PSA-18-00355

Preliminary Site Analysis Report

PSA #: PSA-18-00355 **Map #:** 17-17-11040-0015
Issue Date: 7/25/2018 **Expiration Date:** 7/25/2019
Parcel #: 825033 **Site address:** 7501 MANASTASH RD
ELLENSBURG
Owner: WILLIAMS, MITCHELL F
PO BOX 1702
ELLENSBURG, WA, 98926-1929
MITCH@MFWILLIAMS.NET;
JULIE@MFWILLIAMS.NET, 899-
0168
Proposed use: NEW BRIDGE OVER MANASTASH CREEK

Manastash Creek Bridge at Williams Property

PROPOSE BRIDGE
MITCH & JULIE WILLIAMS
7501 MANASTASH RD.
ELLENSBURG, WA.

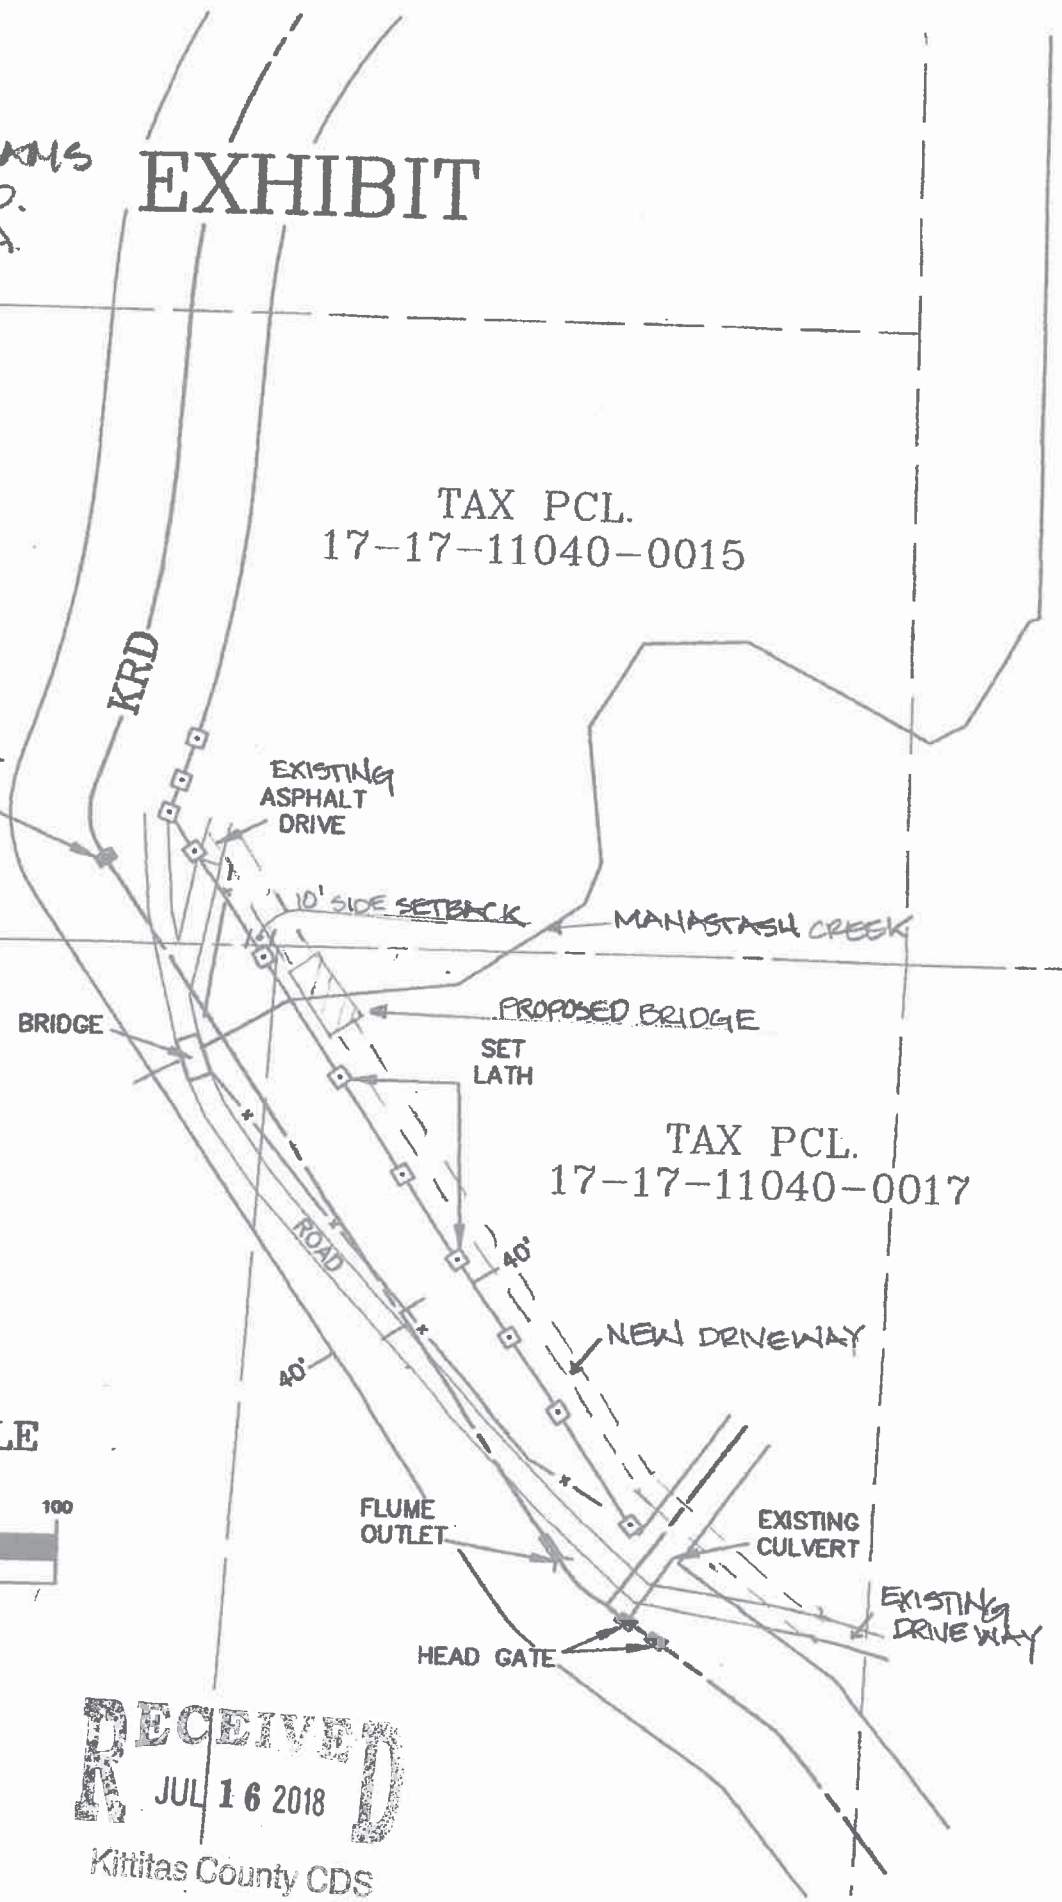
- PLEASE SEE THE ATTACHED BRIDGE POLICY #27. DEPENDING ON LOCATION OF THE STRUCTURE ON THIS PARTICULAR SITE, BOTH EXPOSURES MAY BE APPLICABLE. PLEASE PROVIDE AN ACCURATE SITE MAP TO RECEIVE A DEFINITIVE ANSWER. UNTIL THEN, USE EXPOSURE FACTOR 1.2 FOR A CONSERVATIVE ANSWER.

- SEE ATTACHED WUIC AND DEFENSIBLE SPACE REQUIREMENTS. AREA OF DEFENSIBLE SPACE MUST BE OUTLINED ON SITE PLAN SUBMITTED FOR BUILDING PERMIT. IF THIS STRUCTURE CONTAINS HABITABLE SPACE, ADDITIONAL DEFENSIBLE SPACE WILL BE REQUIRED. YOU MAY BE ABLE TO MITIGATE BELOW THE IR RATING BY APPLYING FOR THE WUIC APPLICATION. NON-HABITABLE SPACES MORE THAN 50 FEET FROM HABITABLE SPACES DO NOT REQUIRE SPRINKLERS. PLEASE TELL US IF ANY PORTION OF THIS SHOP WILL BE USED FOR HUMAN HABITATION OR IT WILL BE CLOSER THAN 50 FEET TO HABITABLE SPACES.

Well/Septic:	No
Setbacks? :	Yes
Scale?:	Yes
All Structures? :	N/A
Critical Areas?:	Yes
Access? :	Yes
WUI Defensible Space? :	No
Easements?:	No
Comments:	Final site plan must depict any applicable wells and septic systems to determine that setbacks and protection zones are observed, along with any applicable defensible space and easements.
